ADDENDUM NO. 3

**For: Elementary School # 38
522 Brookewater Boulevard
Rosenberg, TX 77471
for
LAMAR CISD
3911 Avenue I
Rosenberg, TX 77471**

PREPARED BY: PFLUGER ARCHITECTS, L.P.

PROJECT NO: 24-028

ACOUSTICAL WALL PANEL NOTES:
1. BASIS OF DESIGN: MOMENTUM, FELTRO
AWP-1: FELTRO, CLOUD
AWP-2: FELTRO, SLATE
AWP-3: FELTRO, SPA

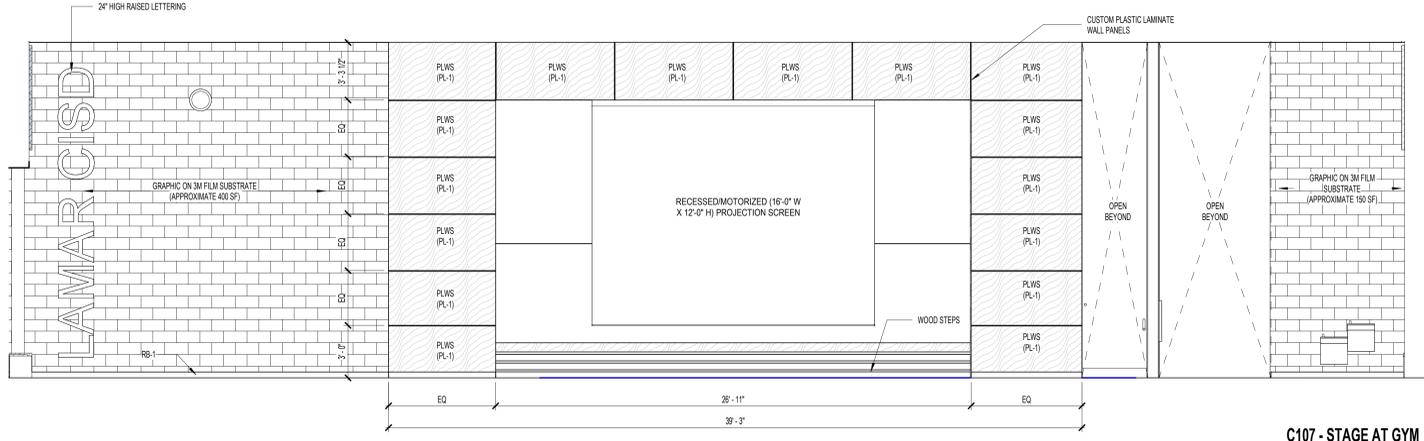
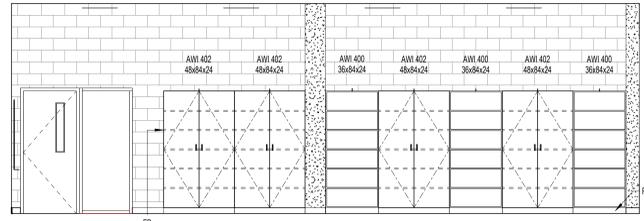
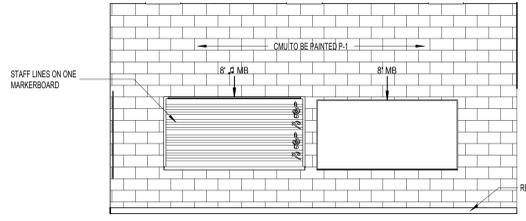
ITEM	SHEET	DESCRIPTION
D3-1	A1.06	Adjusted dimensioning on detail 2
D3-2	A9.00A	Adjusted material schedule for AWP - 1, AWP - 2, AWP - 3
D3-3	A9.00B	Updated remarks on material schedule for gym C107
D3-4	A9.00B	Changed floor type to sealed concrete on rooms B127, E130, and A125
D3-4	A9.01A	Moved weapon rack In A115
D3-5	A9.01A	Modified library casework schedule
D3-6	A9.01A	Updated Floor in room A125
D3-7	A9.01A	Removed wall clocks in rooms A106, A108, A109, A121, A122, A123, A124.
D3-8	A9.01B	Updated Floor in room B127
D3-9	A9.01E	Updated Floor in room E130
D3-10	A9.10	Modified casework and added Weapon rack to elevation 16
D3-11	A9.12	Added note regarding high impact wall acoustical wall panels in elevation 2 and 3

C2.00
DEMOLITION PLAN

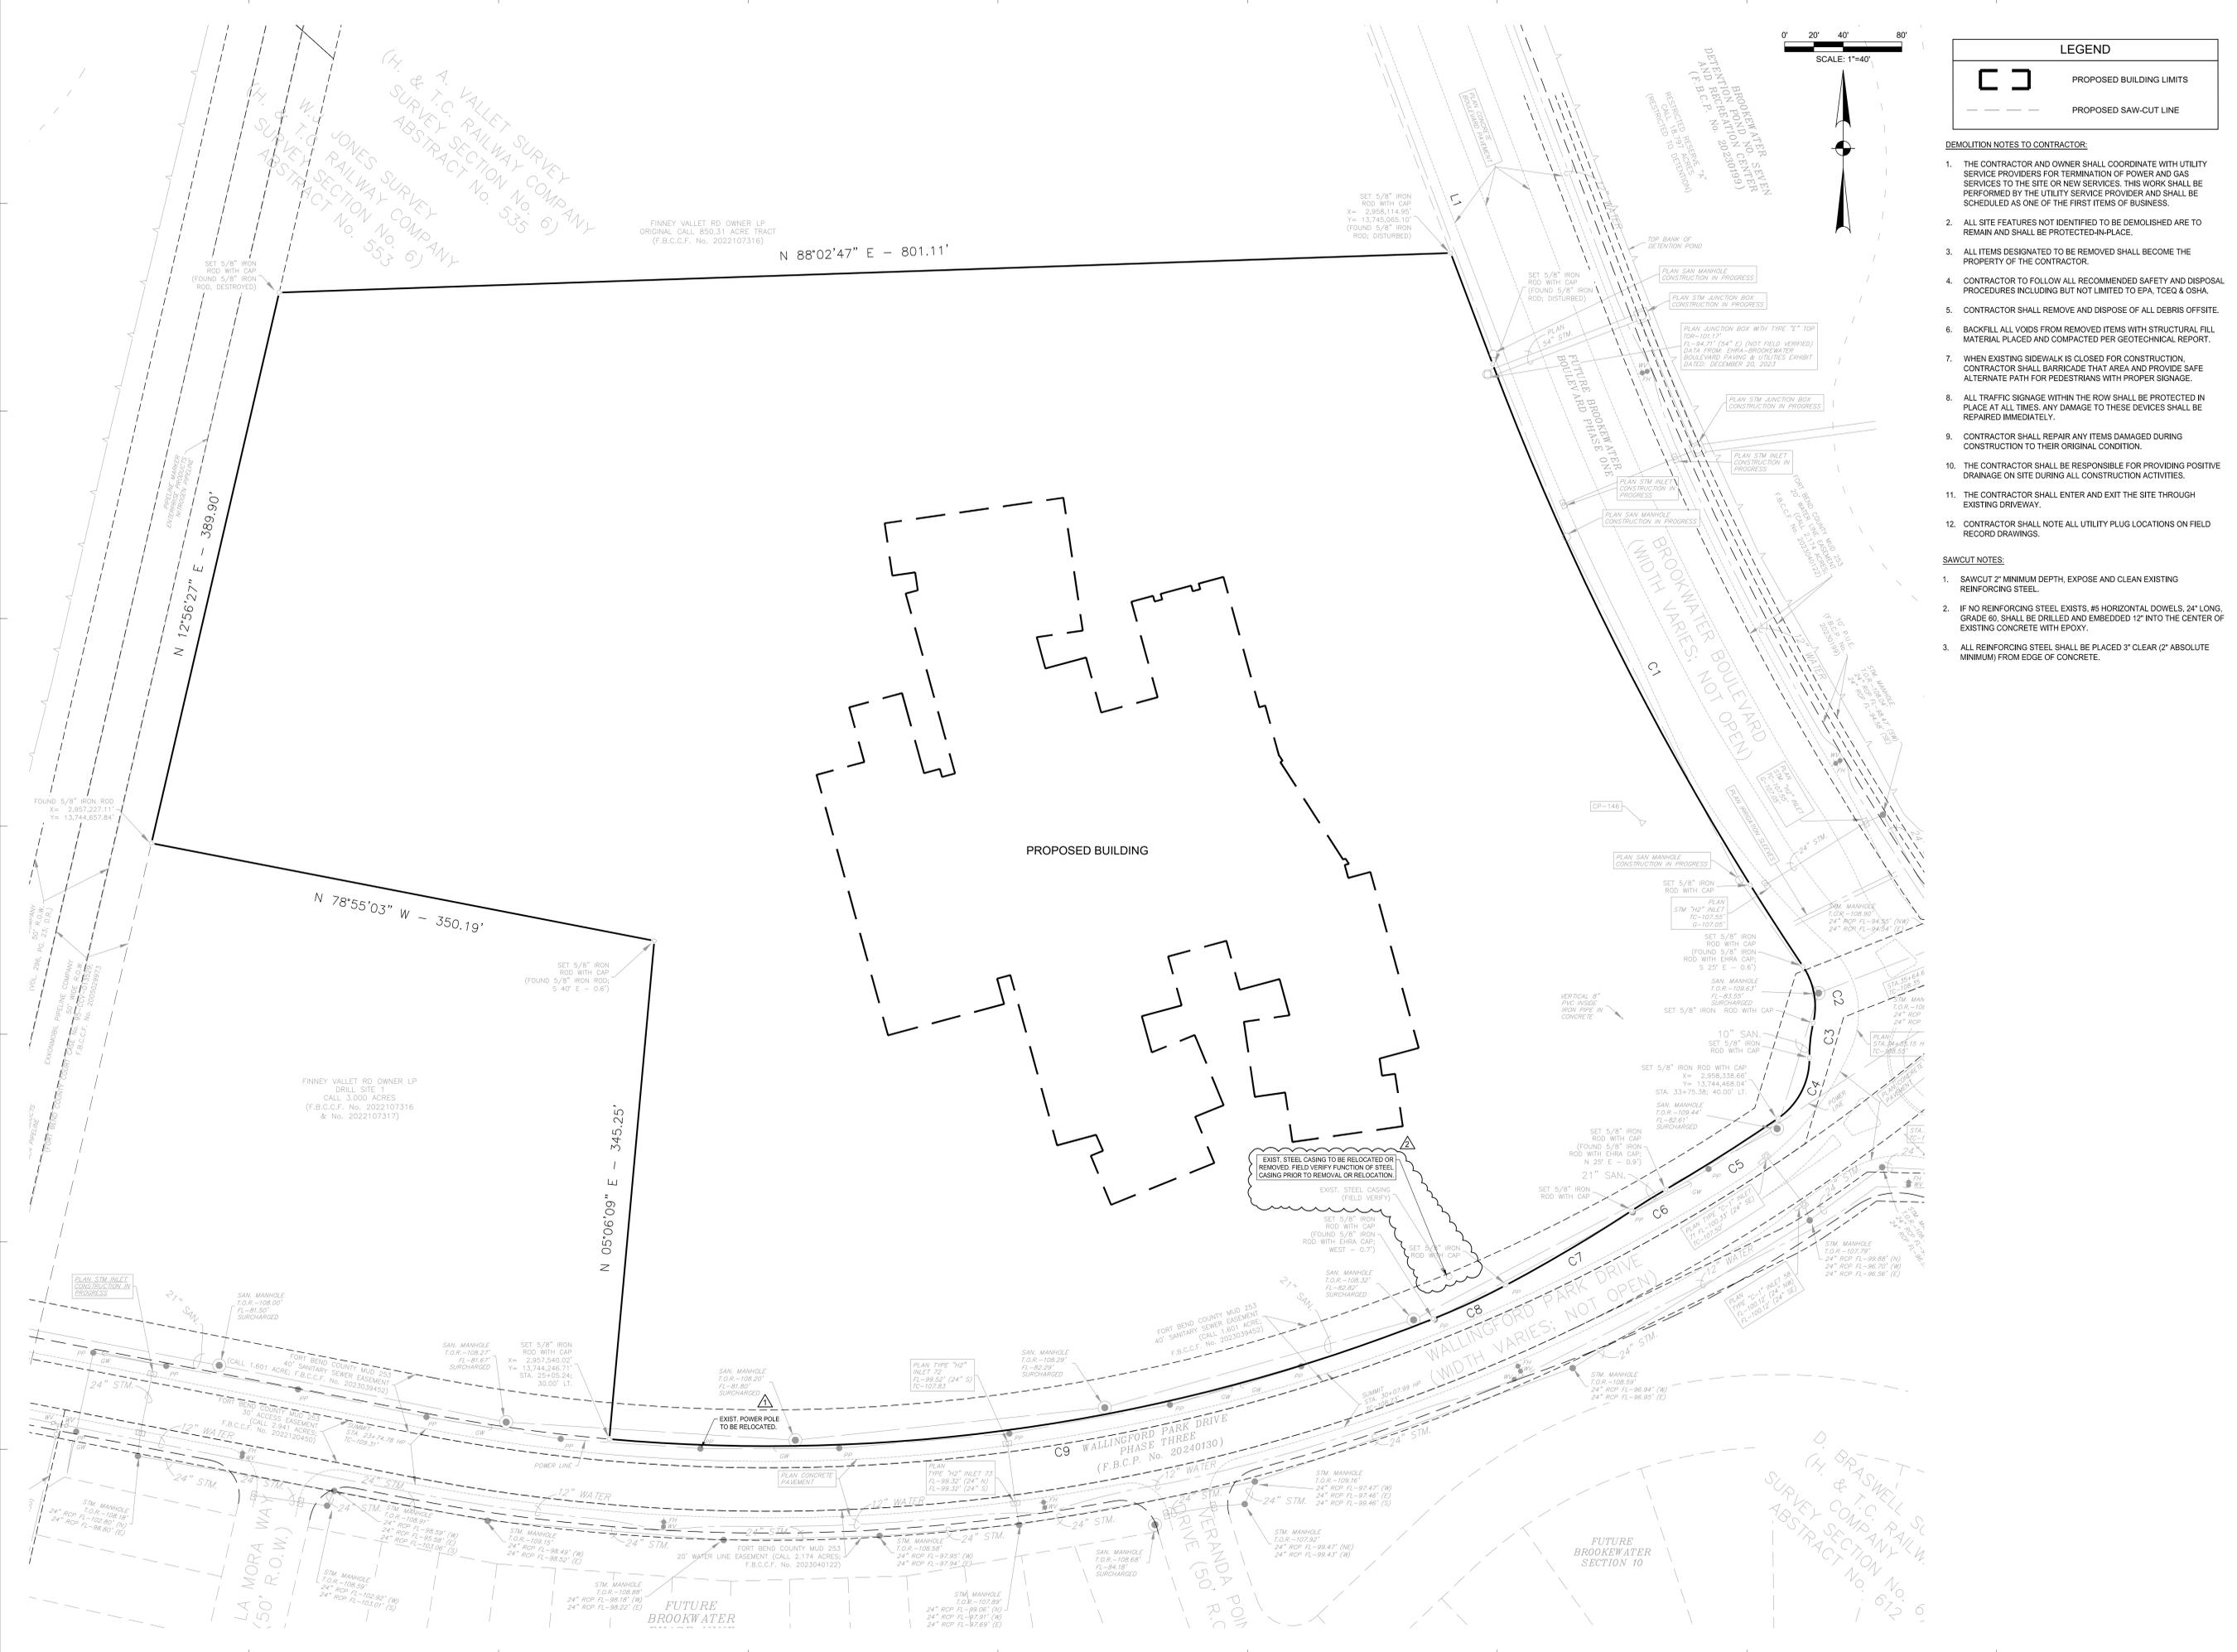
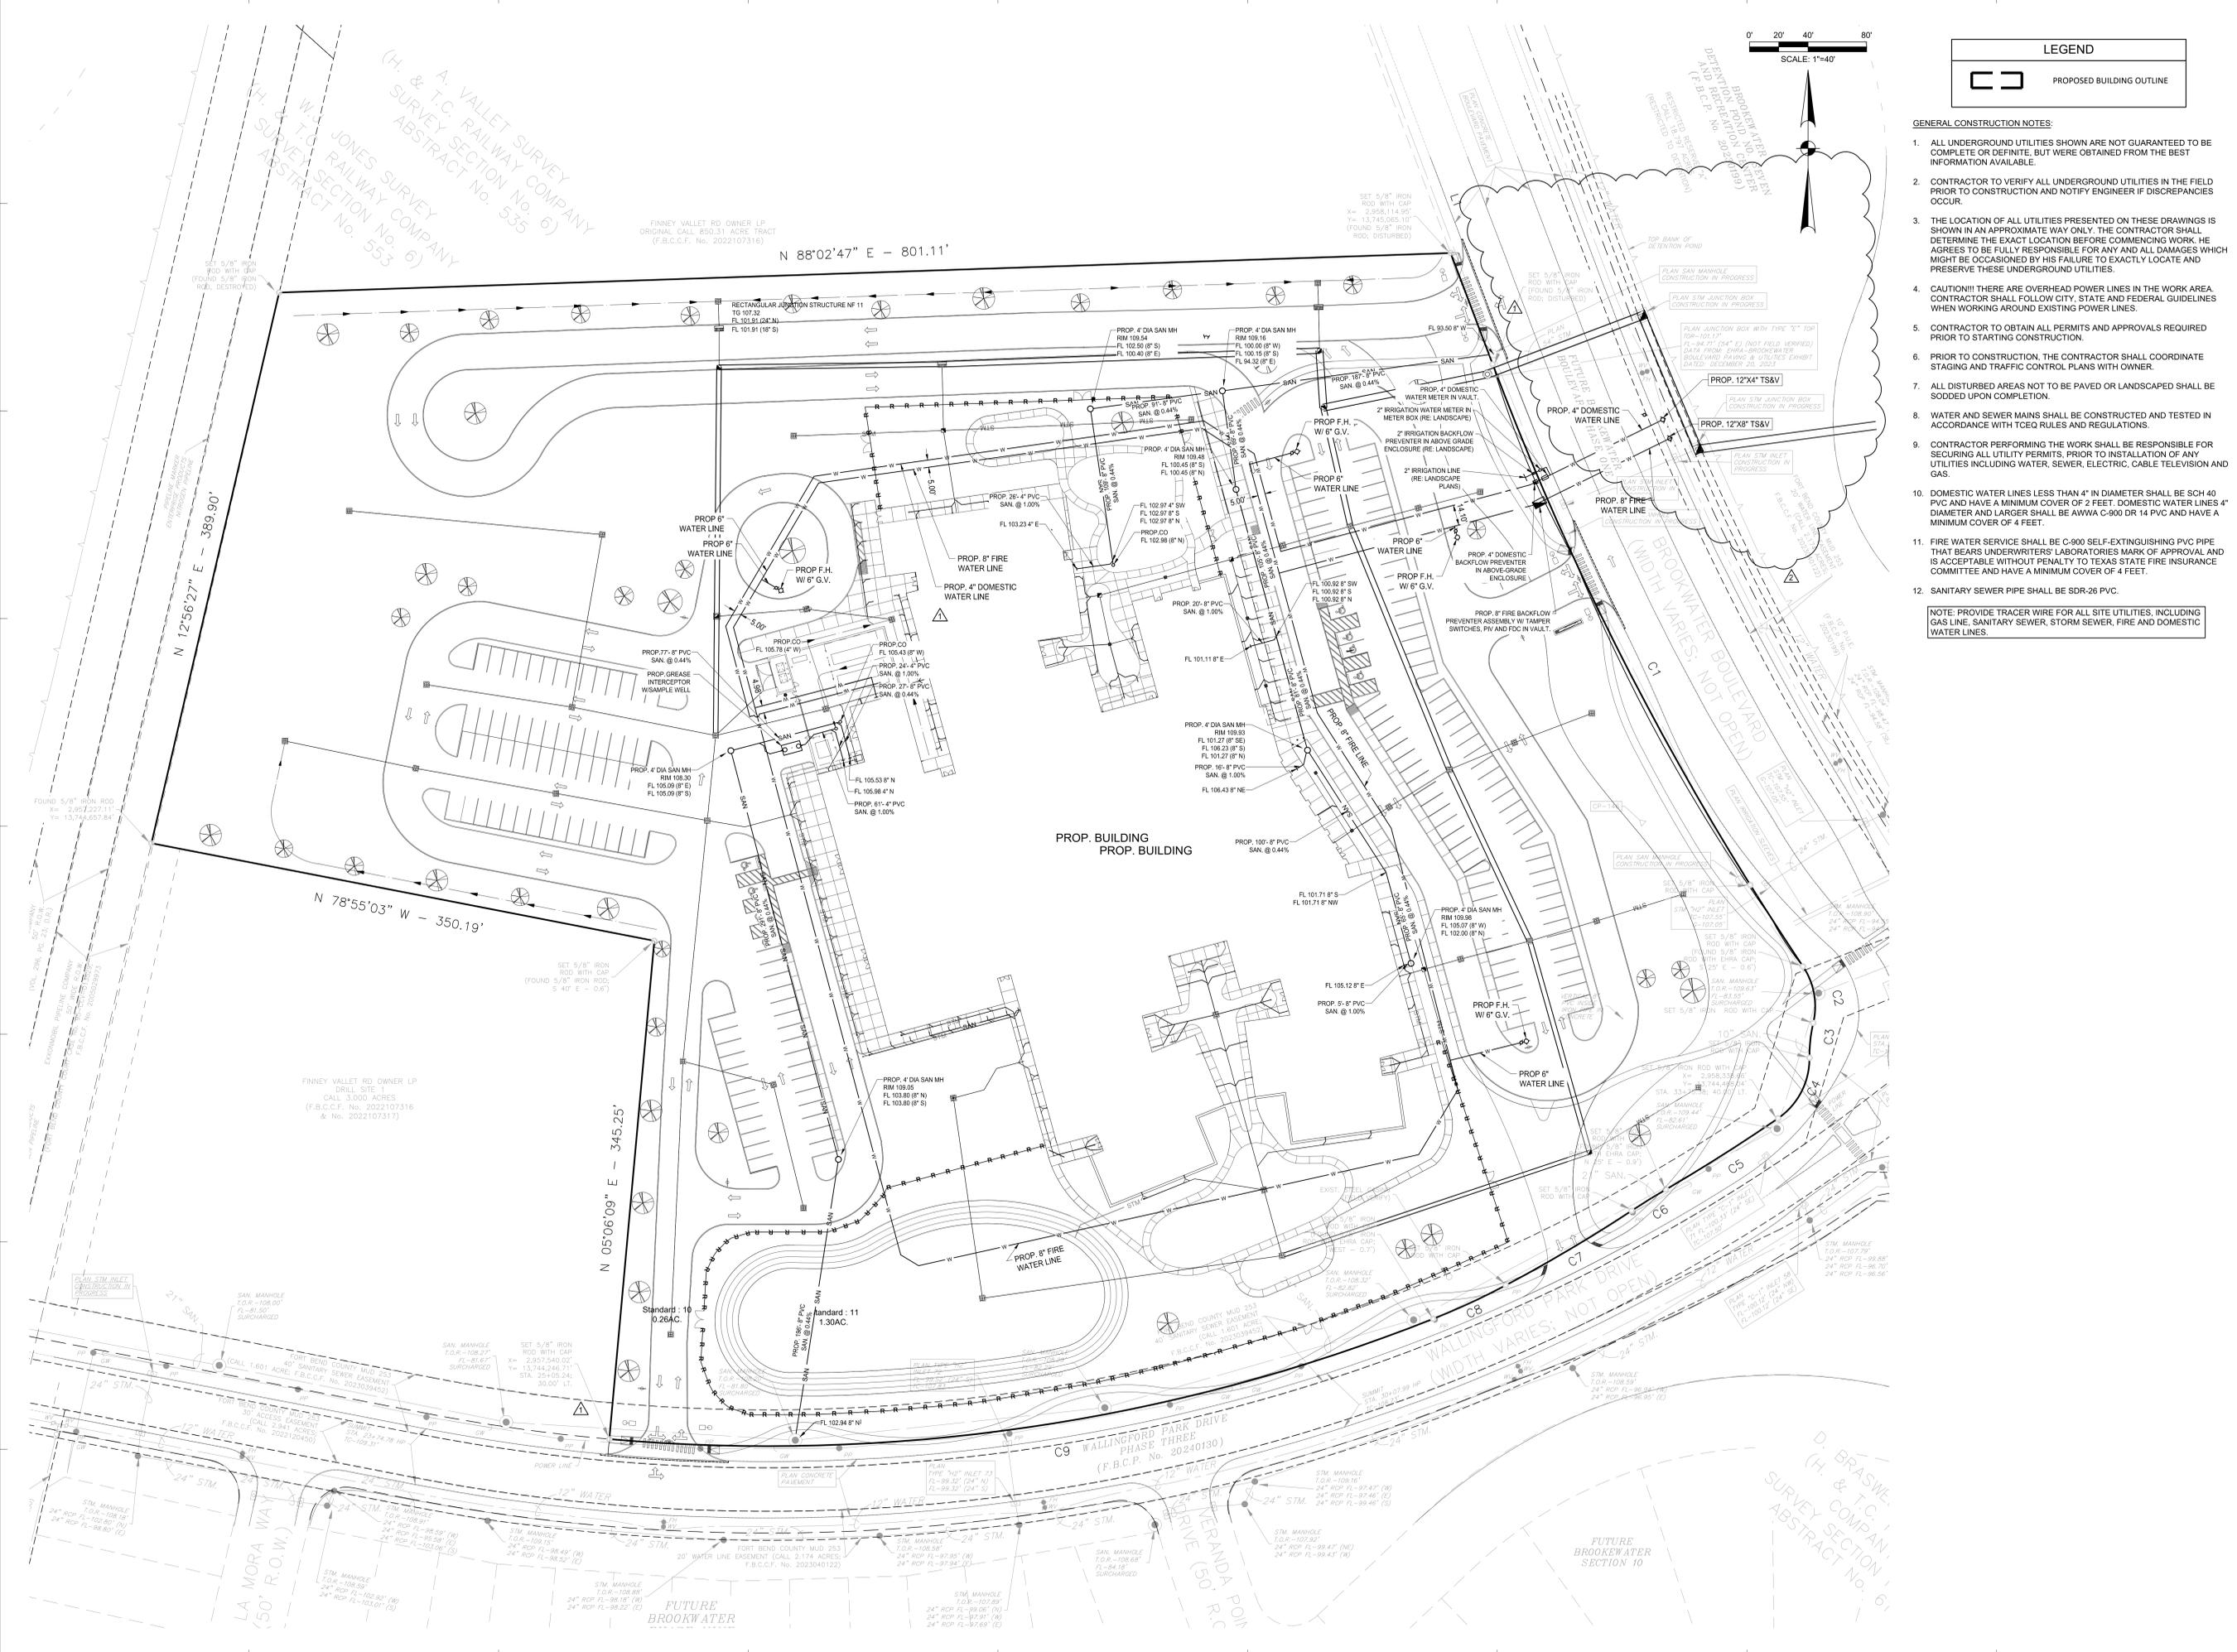
C2.00 DEMOLITION PLAN

- Added linework for existing steel casing.
- Added linework to remove or relocate existing steel casing.
